Historical Affairs and Landmark Review Board

HALRB Case 16-04 (HP1600012)

A request by Francisco Hernandez & Elsa Arcila, owner of 3316 21st Avenue North in the Maywood Neighborhood Historic District, to construct a second story on the existing rear addition and other minor alterations

CERTIFICATE OF APPROPRIATENESS STAFF REPORT

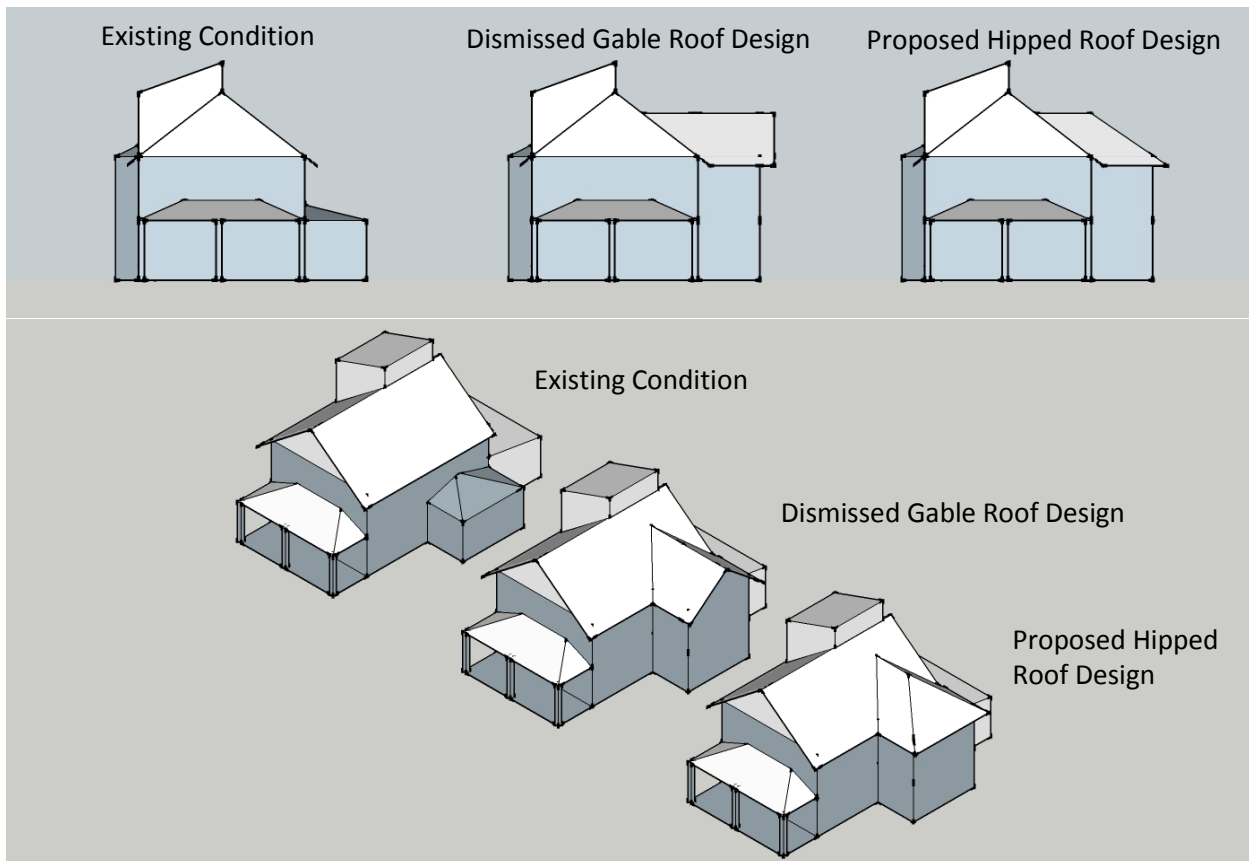
The proposed design complements the historic character of the original dwelling. Staff recommends the use of a hipped roof instead of a gable roof (as originally proposed) on the second-story addition. The hipped roof recalls the design of the existing roof form and allows for the prominent front-gable to remain the focal point of the house from the public rights-of-way. Below is a massing study that illustrates the appropriateness of utilizing a hipped roof on the second-story addition.

On this particular dwelling, staff finds the use of wood-shingles as the primary siding material on the second-story addition appropriate. Staff agrees with the DRC’s analysis that the use of other siding materials (double-worked wood siding, vertical wood siding, etc.) would negatively impact the historic nature of the façade. The use of a hipped roof, stepped down from the ridgeline of the front-gable roof, distinguishes this section of the building as an addition.

Fenestration on this addition is limited to the front elevation. The new window on the 2nd story will match the design and size of the windows on the first story.

Staff finds that this requests meets the intent of Chapter 6: New Construction of the *Maywood Design Guidelines* and recommends approval.
